**PLANNING COMMISSION  
SITE PLAN WAIVER REQUEST REVIEW SHEET**

**CASE:** SP-2020-0202C

**PROJECT NAME:** 15th St Office Building

CITY OF AUSTIN – DEVELOPMENT SERVICES DEPARTMENT  
SITE PLAN APPLICATION – MASTER COMMENT REPORT

## San Antonio Street Facade

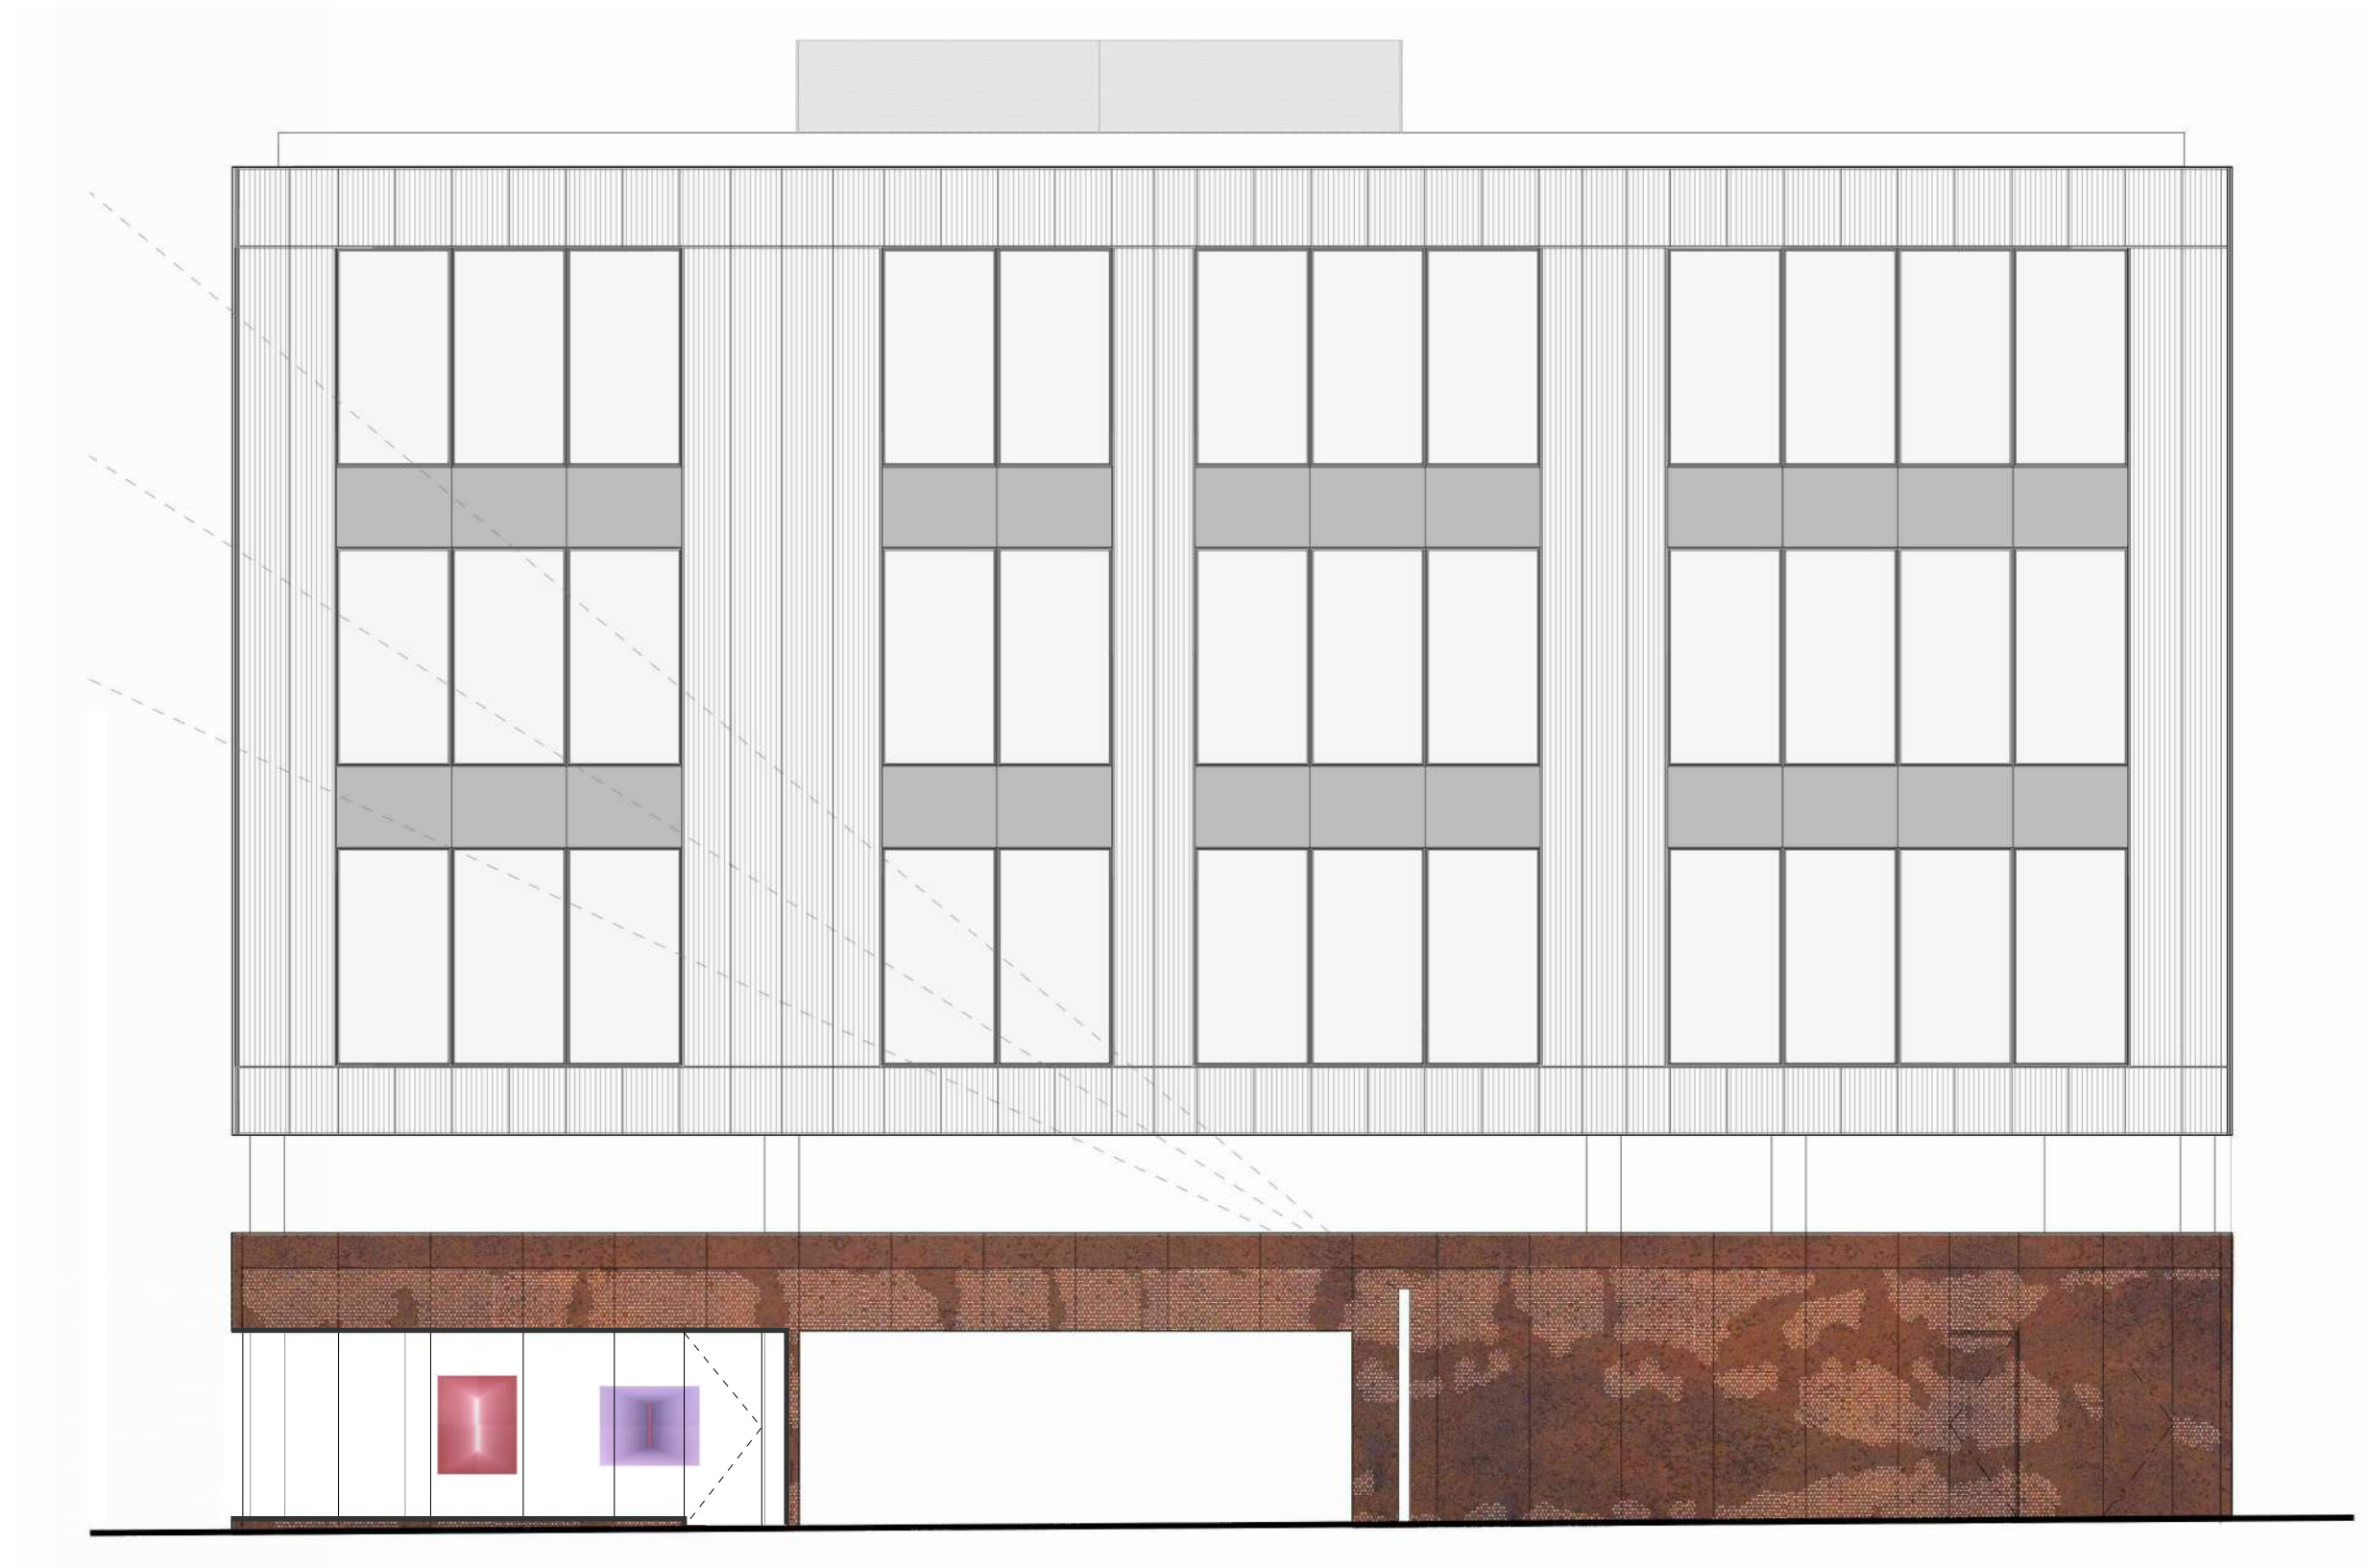
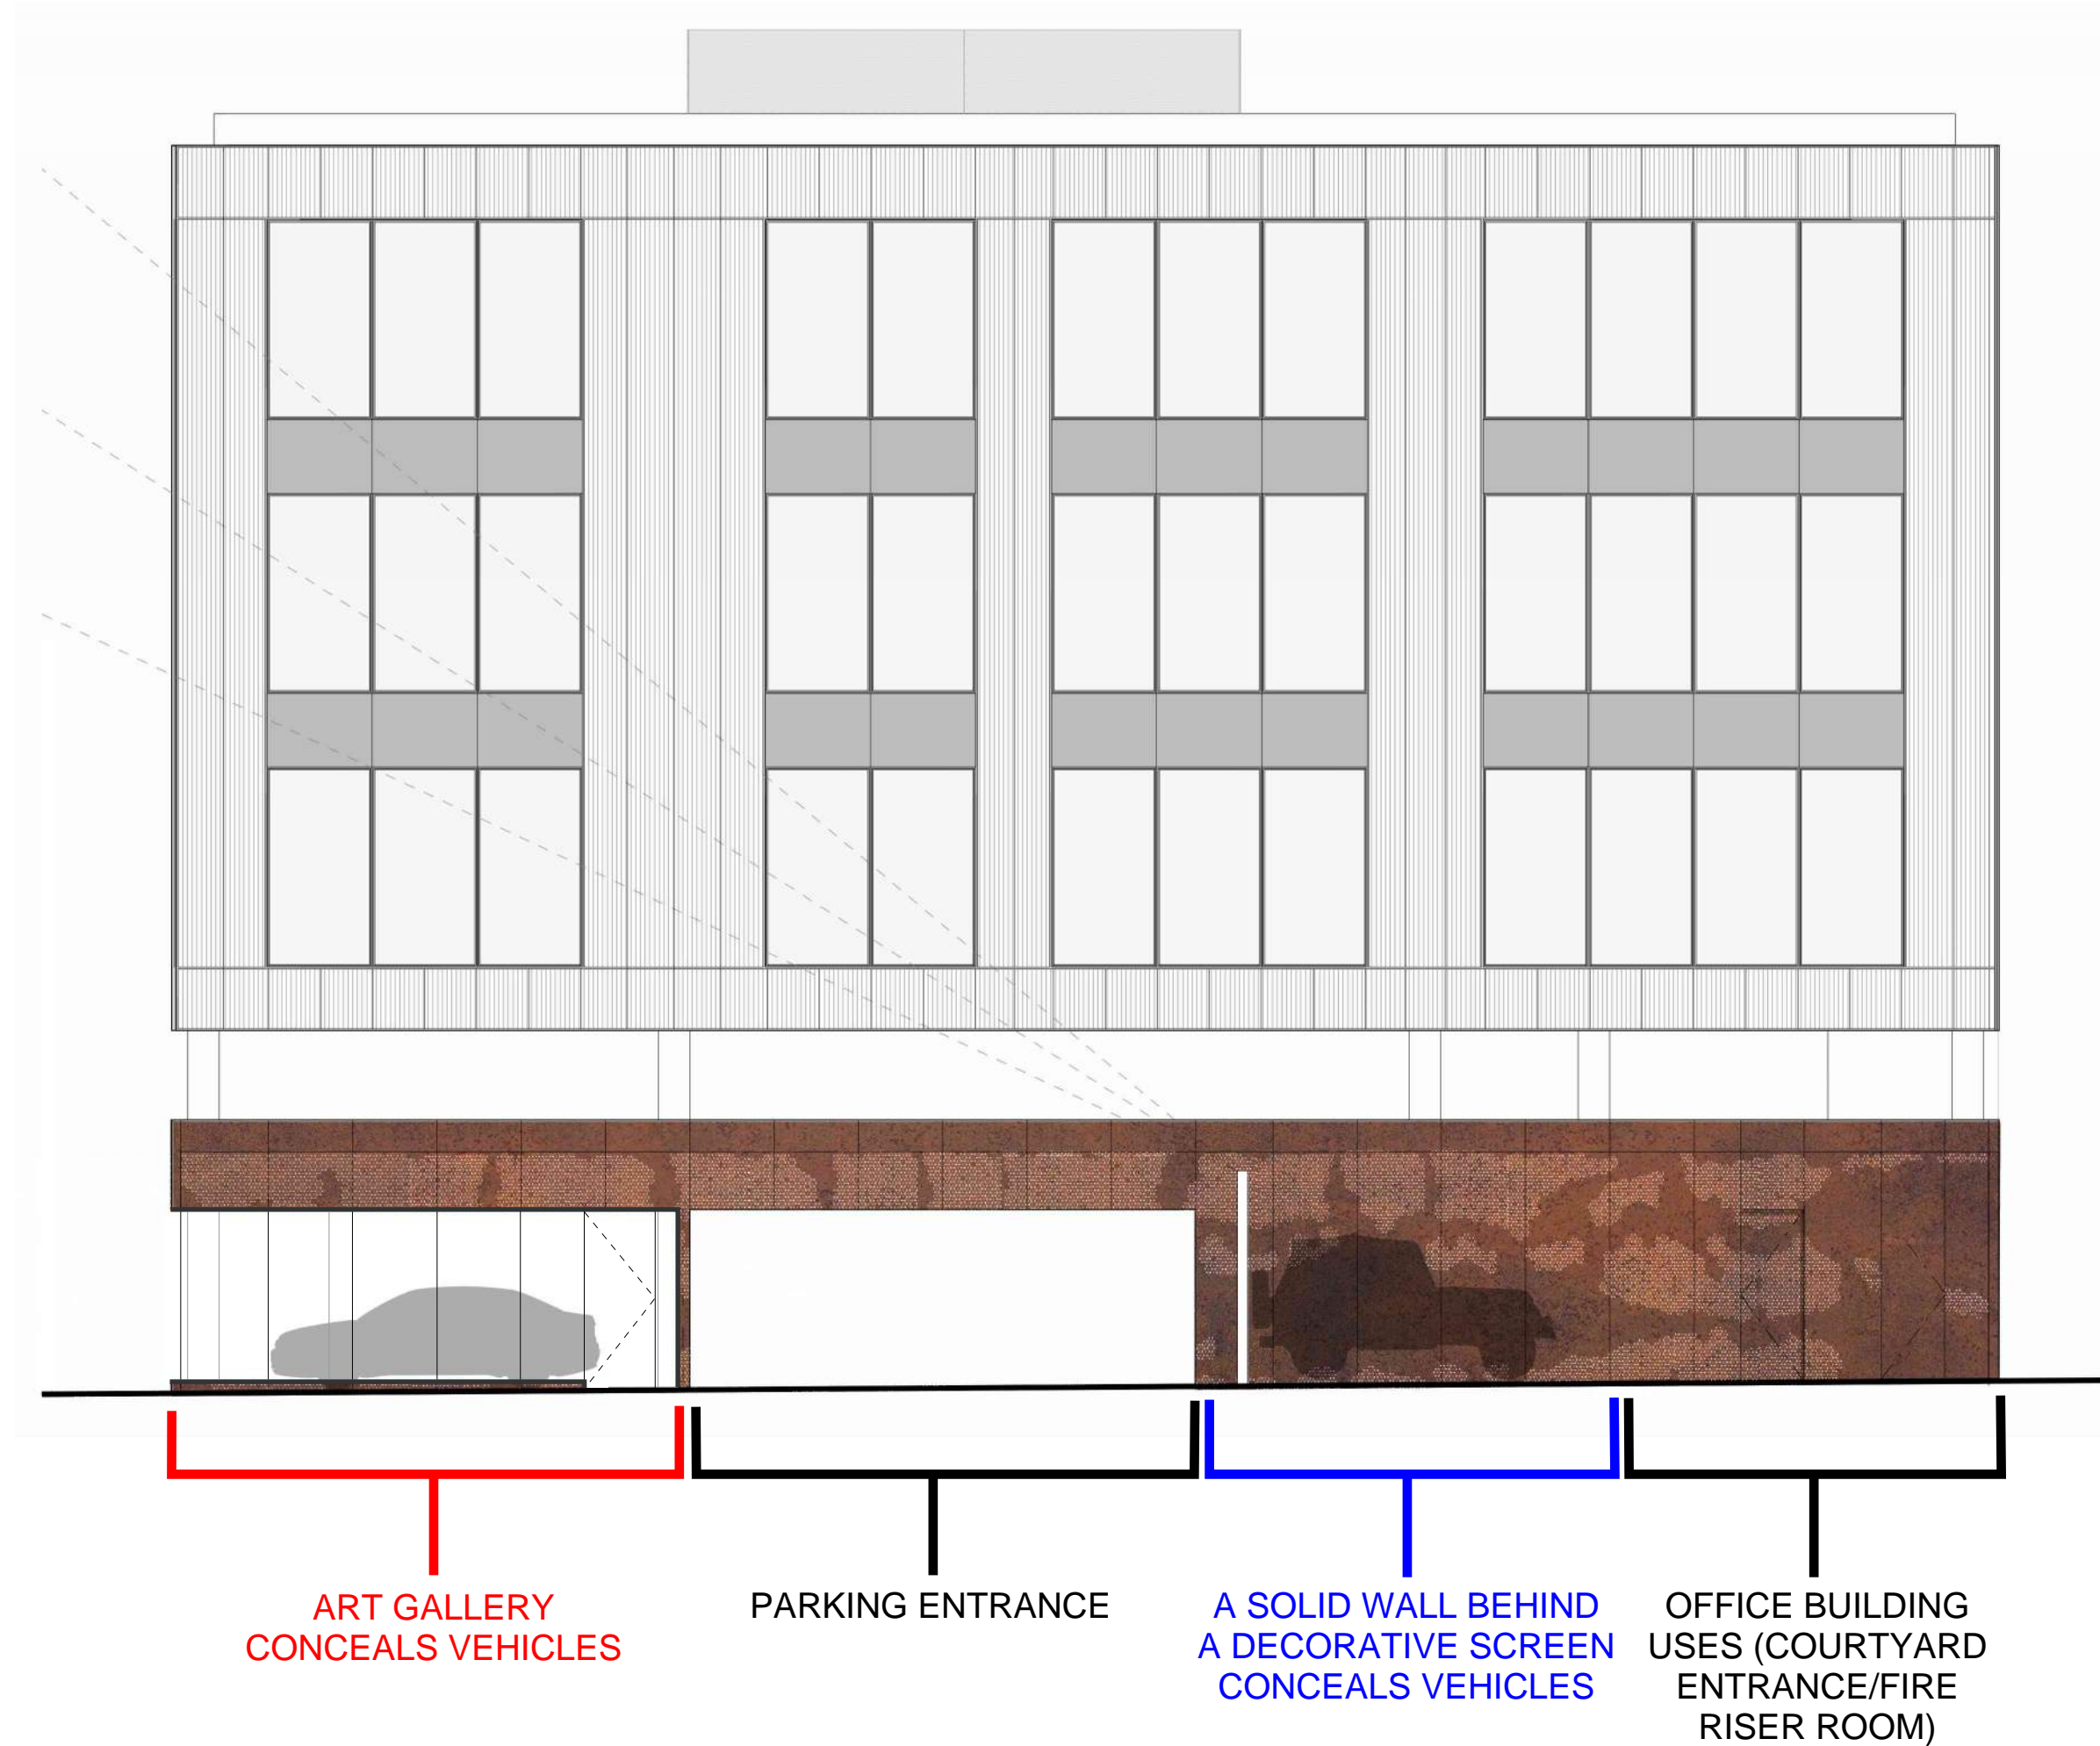
EXCEPT FOR THE GARAGE ENTRANCE, VEHICLES ARE COMPLETELY CONCEALED FROM VIEW WHEN WALKING ON THE SIDEWALK ALONG SAN ANTONIO STREET.

1 SITE PLAN  
Scale: 1/8" = 1'-0"

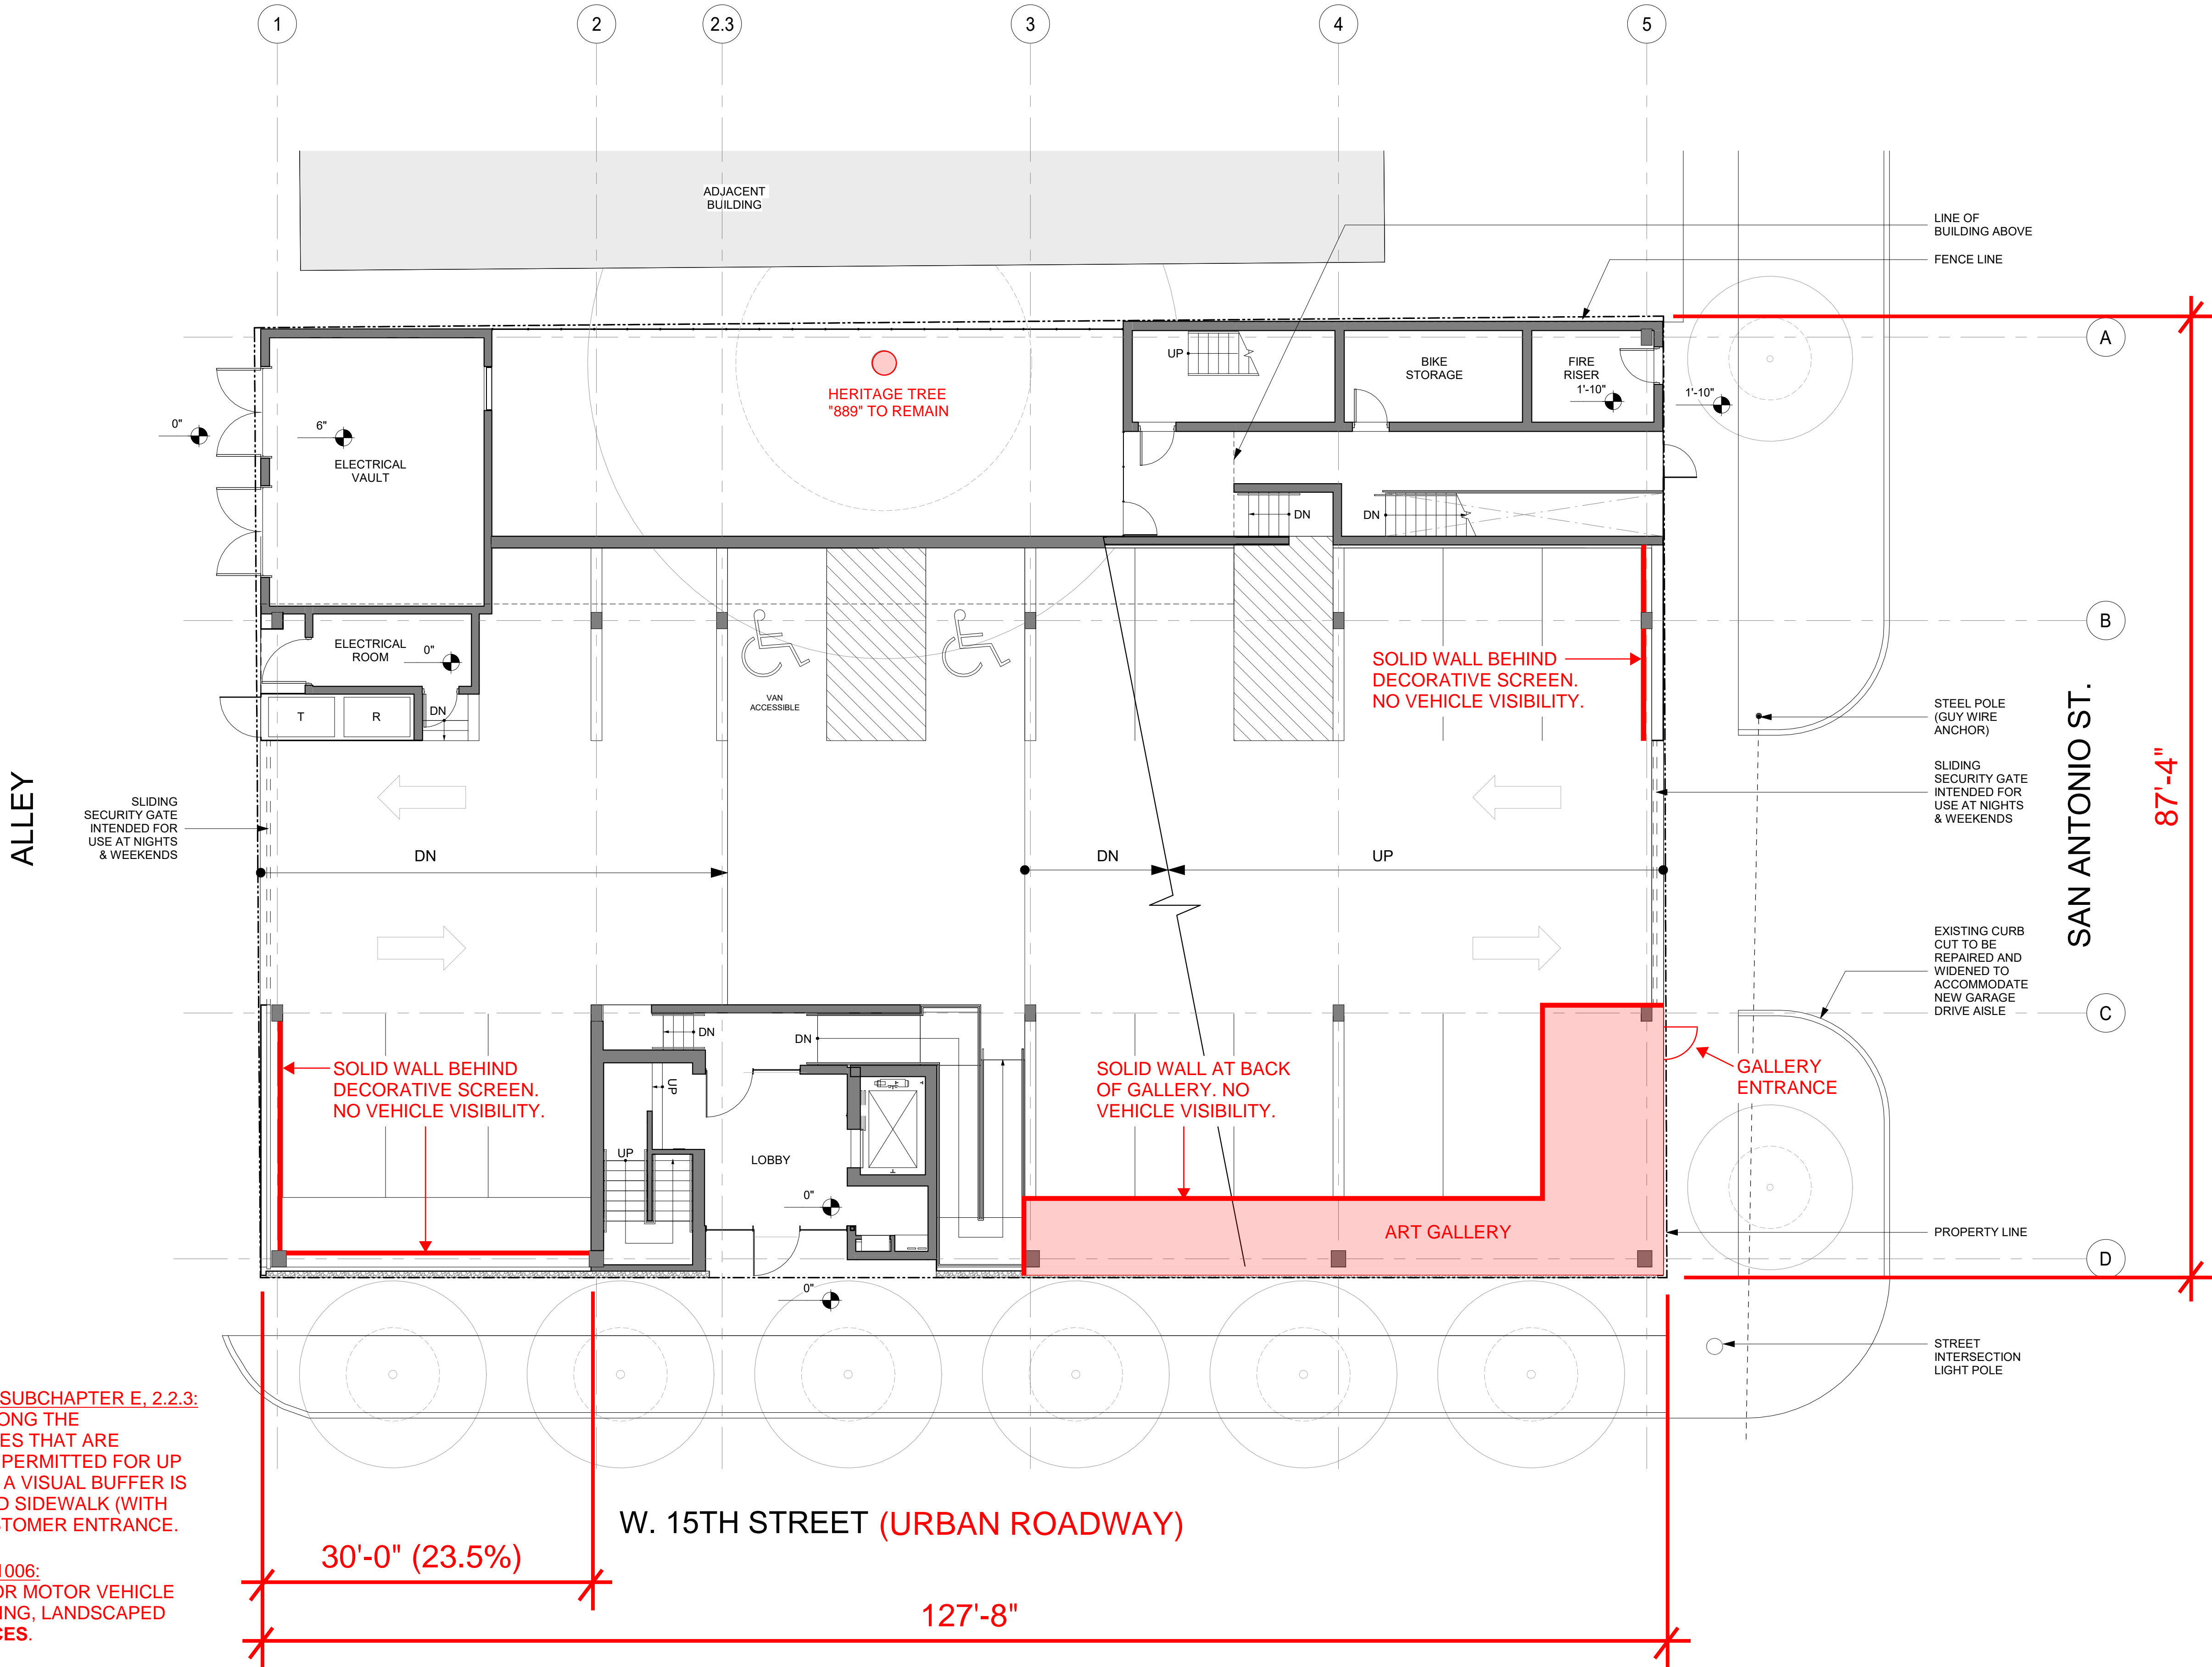
LAND USE DEVELOPMENT CODE, 25-2, SUBCHAPTER E, 2.2.3:  
- SURFACE PARKING IS PERMITTED ALONG THE STREET-FACING FACADE LINE FOR SITES THAT ARE SHALLOWER THAN 400'-0". PARKING IS PERMITTED FOR UP TO 40% OF THE NET FRONTAGE WHEN A VISUAL BUFFER IS PROVIDED BETWEEN THE VEHICLE AND SIDEWALK (WITH TREES) THAT LEADS TO THE MAIN CUSTOMER ENTRANCE.

LAND USE DEVELOPMENT CODE, 25-2-1006:  
- APPROPRIATE VISUAL SCREENING FOR MOTOR VEHICLE AREAS ARE DESCRIBED AS LANDSCAPING, LANDSCAPED BERMS, WALLS, OR **DECORATIVE FENCES**.
